Shearon Harris Nuclear Power Plant, Unit 1
Docket No. 50-400/Renewed License No. NPF-63

Subject: Response to Request for Additional Information #4 Regarding License Amendment
Request to Revise Technical Specification Table 3.3-4 Loss of Offsite Power 6.9 kV
Emergency Undervoltage Primary Setpoints (TAC No. MF4294)

Response to Request for Additional Information #4
License Amendment Request to Revise Technical Specification Table 3.3-4
Loss of Offsite Power 6.9 kV Emergency Undervoltage Primary Setpoints

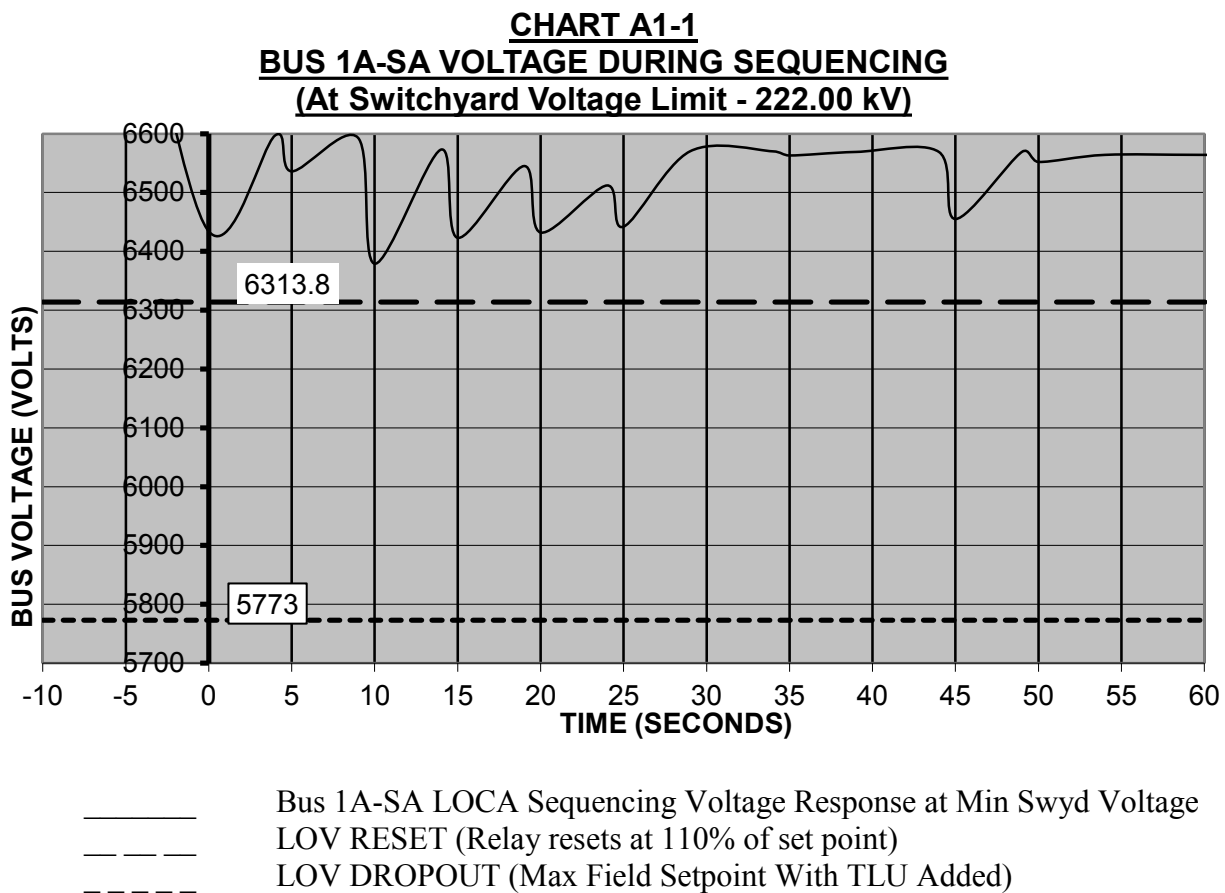
EEEB RAI 2, Request 3

In the calculation No. 0054-JRG attached to LAR, the licensee calculated a maximum pickup/reset value of LOV as high as 105.23 V. The licensee stated that a pickup value of 105.23 V is acceptable because it is less than the minimum degraded voltage relay dropout setting of 106.73 V.

The staff finds the pickup (reset) voltage value as 105.23 V of 120 V = 87.7 percent very high, which does not provide an adequate margin from the degraded voltage relay dropout setting of 106.73 of 120 V = 88.9 percent. The staff considers that the analytical and reset voltage values of LOV relay should be lower than the minimum voltage calculated at the 6.9 kilovolts (kV) safety-related buses during starting of LOCA sequencing loads any time after the safety injection signal, based on the minimum switchyard voltage (after the unit trip). Please provide a curve showing the minimum voltages at the 6.9 kV safety-related buses during 55 seconds of starting of LOCA loads after the safety injection signal based on the minimum switchyard voltage. Super-impose on this curve the analytical and reset voltage values of LOV relay settings to confirm that adequate margin exists so that the motors would not trip out by the LOV relay during LOCA loads sequencing.

EEEB RAI 2, Request 3 Response

Chart A1-1, shown on page 6 of this enclosure, was developed using Chart A1-1 out of E-6000, Revision 12. This chart was initially developed to demonstrate adequate margin for the DGV settings which are higher than the LOV settings. The DGV values from this table were then replaced with the LOV values to develop a similar plot to show the LOV setting as compared to the LOCA response profile. From this graph, it is shown that the voltages seen during LOCA sequencing are well above the LOV dropout and pickup values. Chart A1-1 shows that there is adequate margin and the LOV setting would not be reached during a LOCA at the minimum switchyard value.

Note: The chart above is for the A train. The B train is similar and the conclusions are the same, so only one representative graph is being provided. The worst-case voltage dip considering both trains is down to 6370 V (during Load Block 3 on Bus 1B-SB).
